Re: Bus Connects Kimmage to City Centre core bus corridor scheme
Kimmage, Dublin

ABP case ref: 317660

BUSCONNECTS KIMMAGE CORE BUS CORRIDOR SCHEME

Figure 1 Protected Junction TL501 from the NTA's Cycle Design Manual

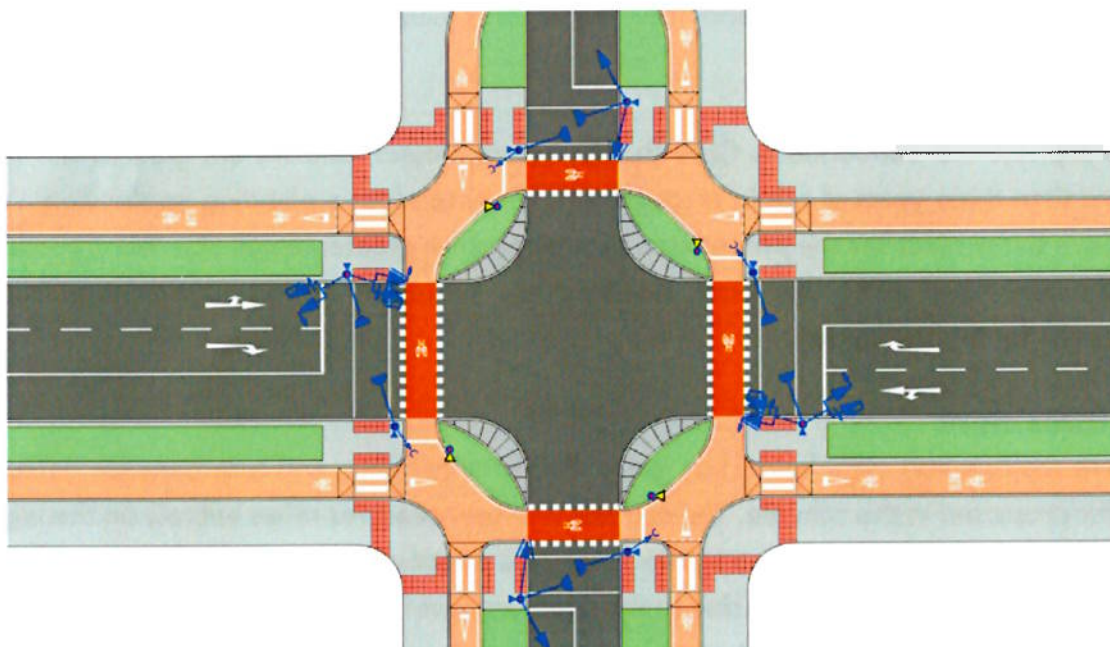
The junction design in the Proposed Scheme does not follow international best practice in junction design and is widely regarded as unsafe. We request that the NTA use Protected Junction TL501 of the NTA's Cycle Design Manual (Dutch-style junctions) throughout the project.

Figure 2 Bus stop with inadequate space to avoid conflict

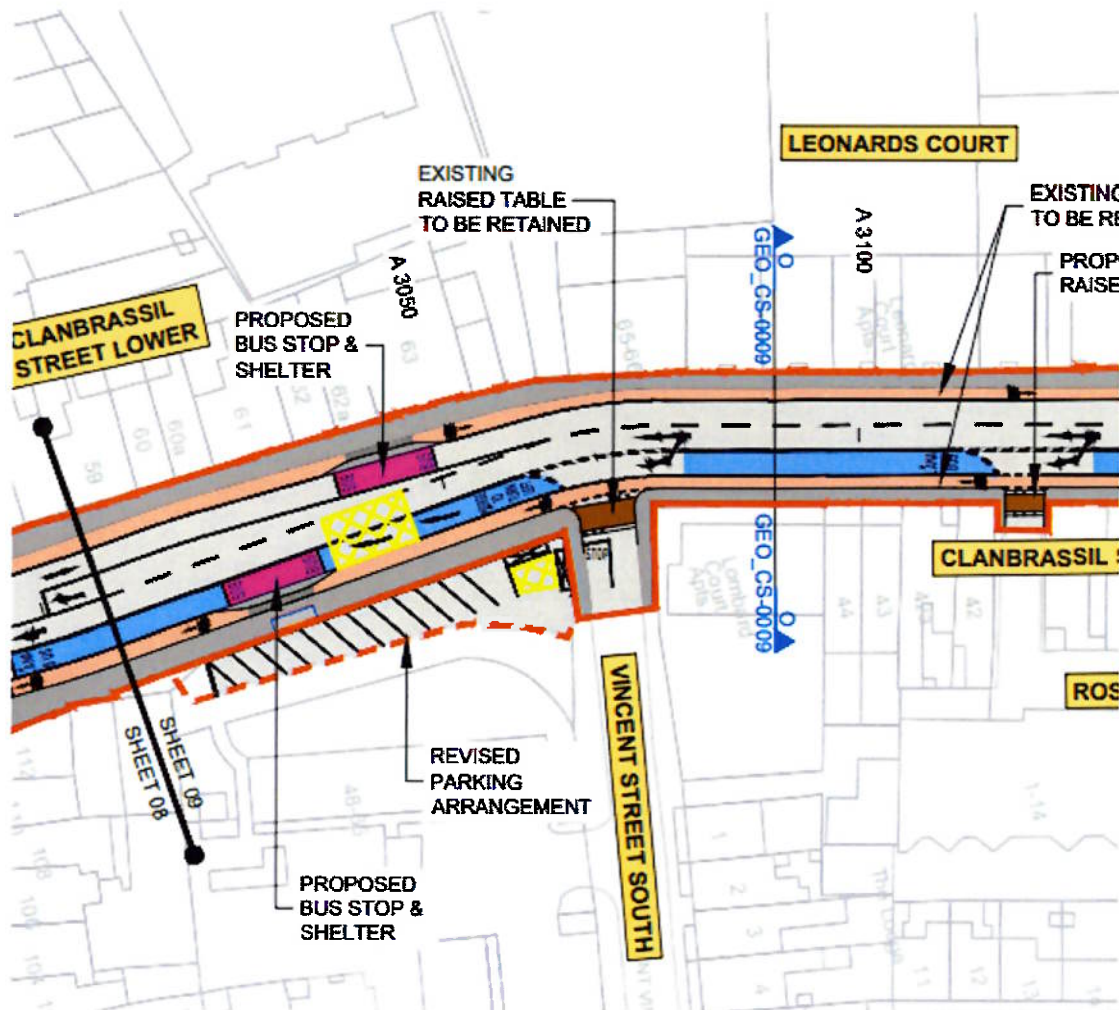
A major concern throughout the Proposed Scheme is the width of the bus stop islands that are proposed and the total lack of bus stop islands in the southern sections. Bus stop islands are crucial for the safety of cyclists and for encouraging all ages and abilities to use cycling infrastructure by removing conflicts between buses and bicycles. However, narrow islands place cyclists in conflict with boarding and alighting bus passengers.

Figure 3 Example of a safer island bus stop design

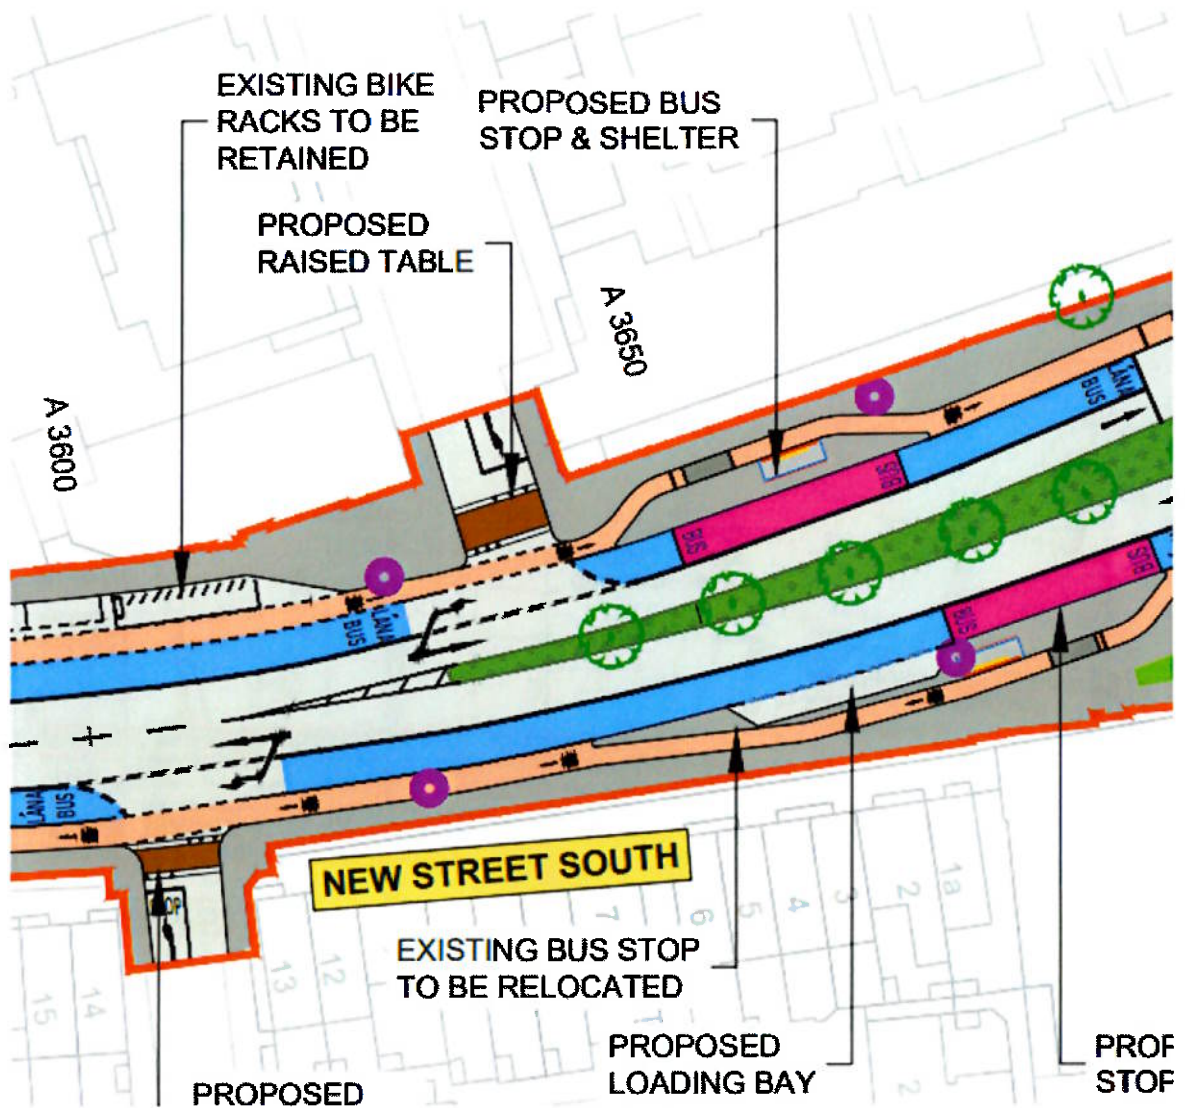
Furthermore, the design proposes routing the cycle track between the bus shelter and the road at several locations. This is not the international best practice and causes unnecessary conflict between bus passengers and cyclists. Figure 4 shows a much safer design on ROAD where the cycle track is routed behind the bus shelter.

Figure 4 Junction without crossings on all arms

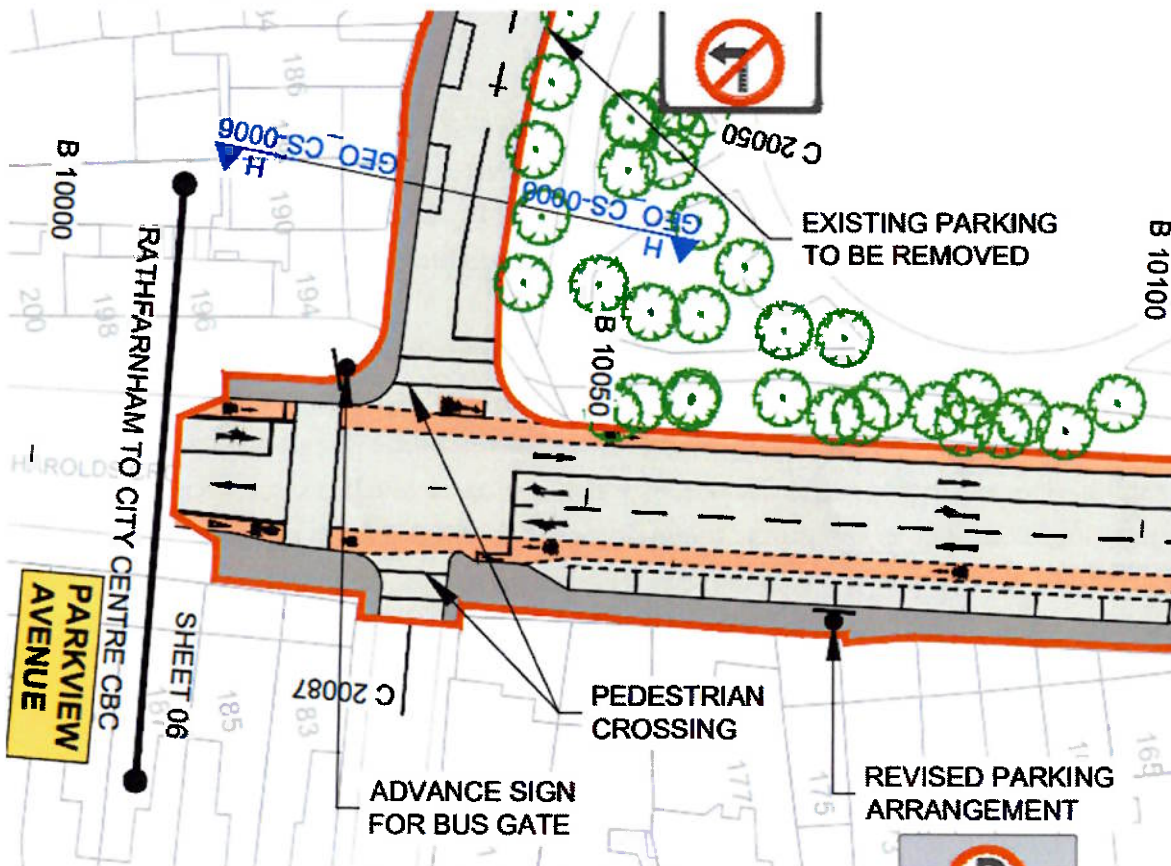
Some junctions are missing pedestrian crossings entirely on one or more arms. These missing crossings mean a pedestrian may need to wait for three lights — or more in the case of two-stage crossings — just to cross the street and continue their journey. Section

4.4.3 Junction Design of DMURS states that “designers should provide crossings on all arms of a junction” and Section 4.3.2 Pedestrian Crossings states “designers should provide pedestrian crossing facilities at junctions and on each arm of the junction”.

These junctions are clearly not in compliance with DMURS:

- Mount Argus View/Kimmage Road Lower
- Harold’s Cross Road/Kimmage Road Lower
- Harold’s Cross Road/Parkview Avenue
